Access Compliance Report

Public Rights-of-Way

Intersection ID: 12134	Main Street: MARLOWE_AV	Cross Street: BERRYHILL_RD	Location: NE
ADA ID: 4EE37737E813	Ramp Type: Perp	Initial Pass/Fail: Fail	Overall Compliance: No
Severity Score: 10			
Codes/Mitigation Info/Possible Solution		Field Measurements/Component Compliance

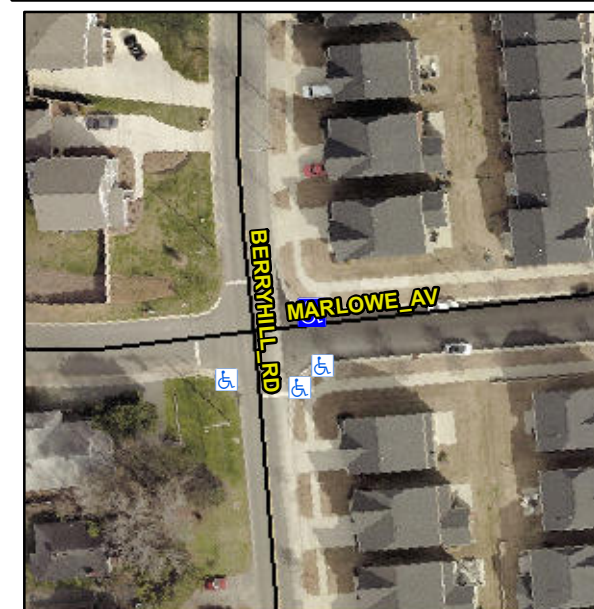
Not Found, R304.5.1, R304.5.3

Compliance	Description	Data	Compliance	Description	Data
N/A	Ramp Length (in)	104.0	Yes	Ramp Slope (%)	5.7
No	Ramp Width (in)	44.5	No	Ramp XSlope (%)	2.9
N/A	Flare Type LT	N/A	N/A	Flare Type RT	N/A
N/A	Flare Slope LT (%)	N/A	N/A	Flare Slope RT (%)	N/A
N/A	Flare Traversable LT?	N/A	N/A	Flare Traversable RT?	N/A
N/A	Landing Length (in)	N/A	N/A	DWS Provided?	N/A
N/A	Landing Width (in)	N/A	N/A	DWS Contrast?	N/A
N/A	Landing Slope (%)	N/A	N/A	DWS Length (in)	N/A
N/A	Landing X Slope (%)	N/A	N/A	DWS Full Width?	N/A
N/A	Landing Curb? (Y/N)	N/A	N/A	DWS Offset (in)	N/A
N/A	Shared Landing?	N/A			
N/A	Gutter Ponding?	N/A	N/A	Gutter Slope (%)	N/A
N/A	Gutter Lip Ht (in)	N/A	N/A	Gutter X Slope (%)	N/A
N/A	Painted X Walk1?	No	N/A	Painted X Walk2?	N/A
	X Walk 1 Direction	To S		X Walk 2 Direction	N/A
N/A	X Walk 1 Width (in)	N/A	N/A	X Walk 2 Width (in)	N/A
	X Walk 1 Slope (%)	3.8		X Walk 2 Slope (%)	N/A
	X Walk 1 X Slope (%)	3.1		X Walk 2 X Slope (%)	N/A

Remove & Replace Entire Ramp.
